Revisions Manuscript:

"A new modelling framework for regional assessment of extreme sea levels and associated coastal flooding along the German Baltic Sea coast"

by Kiesel, J.; Lorenz, M.; König, M.; Gräwe, U.; Vafeidis, A.T.

Answers to reviewer #2

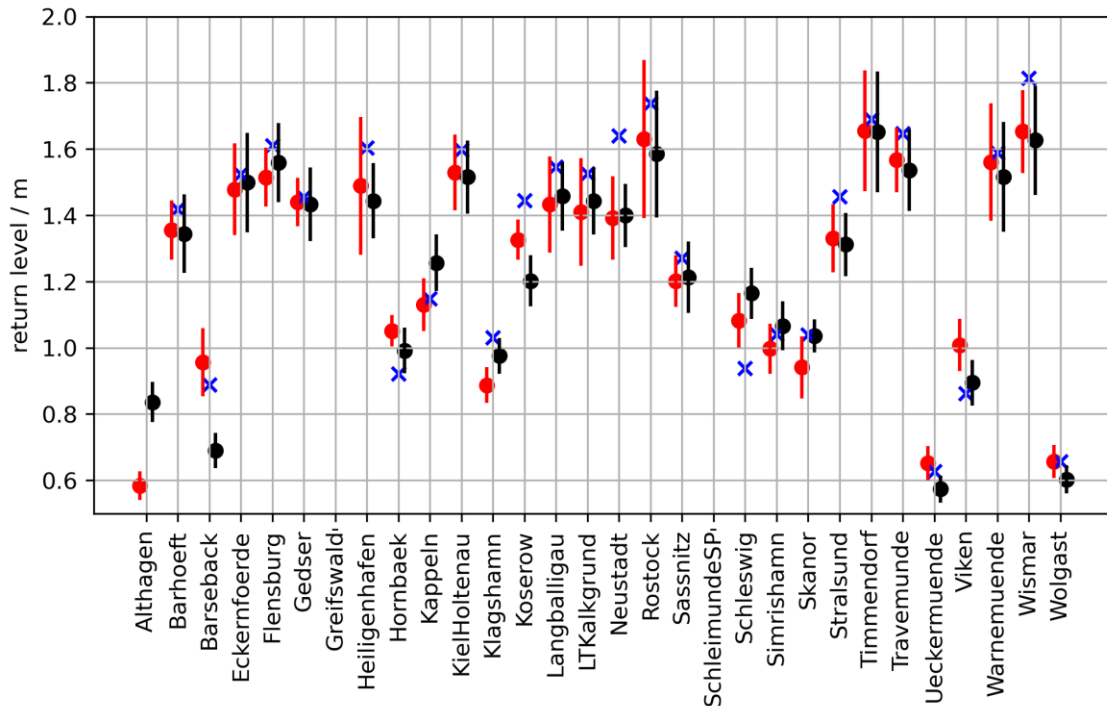
The empirical values in the distribution shown for a TG (Figure 4) show an increasing bias for increasing RPs, but the fit seems insensitive to this. Could you elaborate? This seems also evident from the 2019 event, what is the corresponding RP and how does the error compare to the derived RP error, given that a different meteo forcing is used? The mean (negative) bias for the 2019 event is partly compensated by the positive bias in the stations around some

of the unresolved lagoons, you could leave these out to have a better picture of the model performance for this event? (since TGs are used for the flooding at these locations anyways)

Yes, the model has generally a negative bias, especially the for the high ESLs. However, by overestimating the highest event in the model time period, the statistical fits of the model and the observations are very close, see also the return levels in Tab. 4. For some tide gauge locations, the 200-year return levels from the model are higher than return levels obtained from the observation based GEV. This is especially true for the coast of Schleswig-Holstein, where one event is overestimated by the model, thus influencing the tail of the distribution. However, the 95% confidence intervals are large due to the extrapolation and both, the estimated mean return levels of the model and the observation fall into the confidence intervals of each other.

We have compared the observed/measured (TG) return periods for the 2019 event (blue numbers in Fig. 1) with the return periods calculated with our model (black in Fig. 1). We find that the modelled values are within the respective confidence interval for most locations.

However, the estimation of return periods based on the discrete observations (explanation of the term “discrete observation” provided in caption of Fig. 1) are much smaller for many locations compared to the respective RP from the GEV fits (red numbers for GEV based on observations, black numbers for GEV based on model results). We cannot compare the errors here to other meteorological forcings since we have only run this model for the UERRA dataset. However, for the entire Baltic Sea, Lorenz and Gräwe (2023) show that for a hindcast ensemble of 13 members at ~1.8 km resolution that the ensemble spread of annual mean maximum water levels is in the order of the variability between the meteorological datasets for the 99th percentile wind speeds.

We prefer to not dismiss the lagoons from the comparison, but rather show the limitations of the model resolution.
